**Invitation to Bid: Construction Fire Station 49  
Addendum 8  
November 10, 2025**

This is a cumulative response for architectural, structural, mechanical, electrical, plumbing and fire protection RFI's submitted to date.

**NCFCRD Station #49 Precon RFI**

19. Subject: Fire Caulking at Drywall to CMU Wall Joints

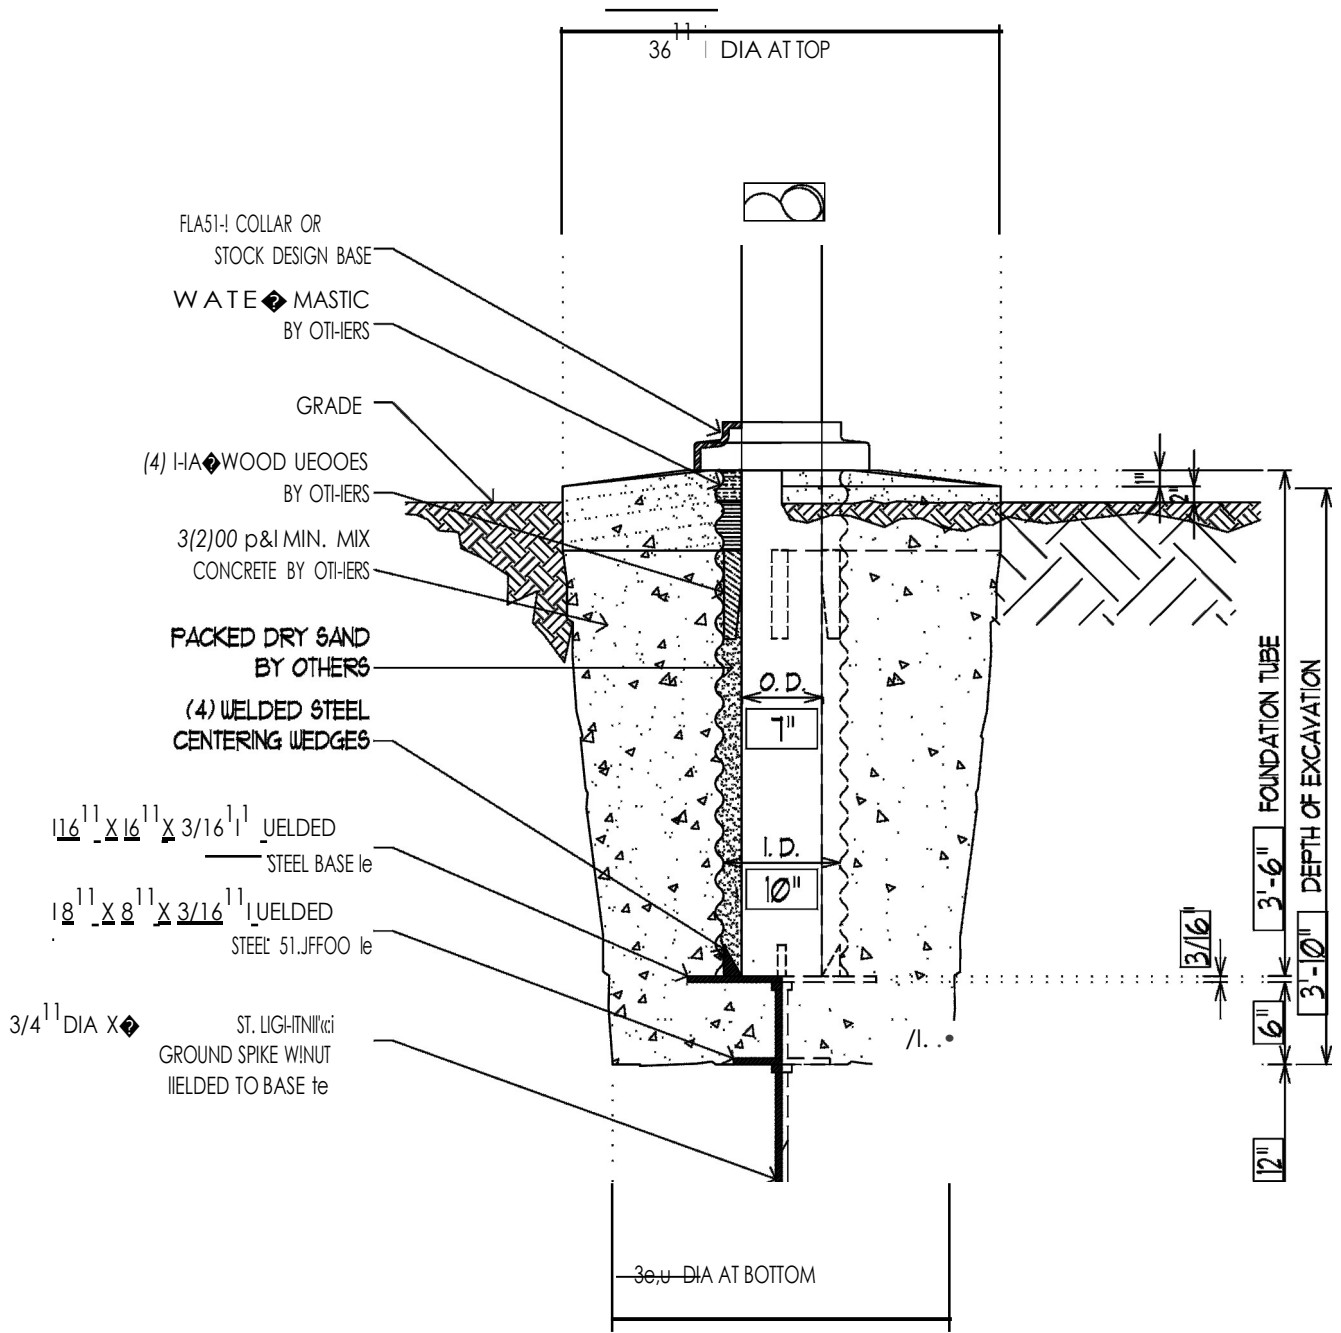
For instance, where drywall board meets the perimeter CMU walls, is fire caulking required at this joint?

- **No. The layer of drywall is acting as an ignition and thermal barrier for the 1/2# spray insulation.**
